Shasha Garments Ltd. (9363)

05.JULY.2014

Identified Priority 1 Concerns

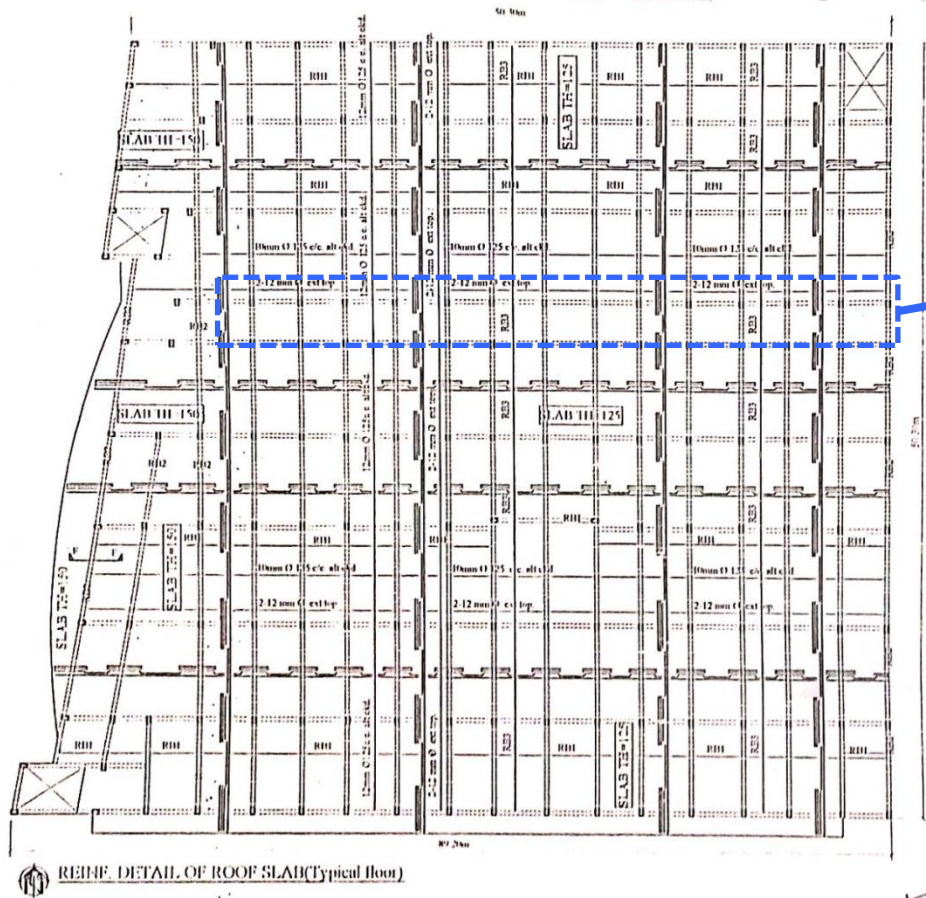
Uncontrolled heavy storage loading was found on 4th floor and 6th floor. We believed the loading on 4th floor and 6th floor to be 4.5 kPa (50 kg per roll, 1.50 x 1.50 m footprint, 20 rolls per stack) and 6.0 kPa (50 kg per bag, 0.70 x 0.60 m footprint, 5 bags per stack) respectively. Loading in this area should be reduced to 2.0 kPa and we require that these items be investigated in the Detailed Engineering Assessment.

Uncontrolled heavy storage loading was found on 1st floor cantilevered slab. This loading was also leaning on the brick walls that lack in lateral load resistance.

Loading in these areas should be removed and we require that these items be investigated in the Detailed Engineering Assessment.

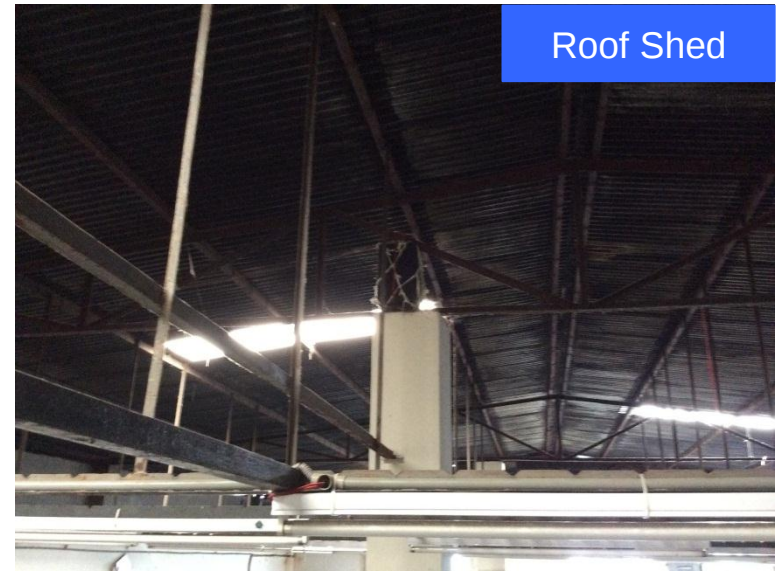
There are no drawings provided for the roof shed of main building. The roof sheds of main building and auxiliary building must be checked for stability and capacity especially the connections. Stability under wind uplift needs to be checked in particular.

Roof Shed

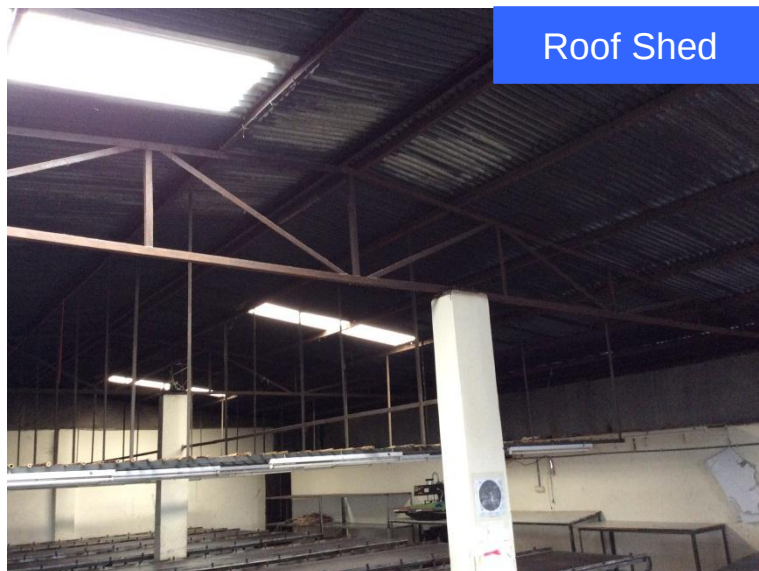
There are no drawings provided for the steel staircase on the east side of this building. The stability and capacity of this steel stair need to be investigated.
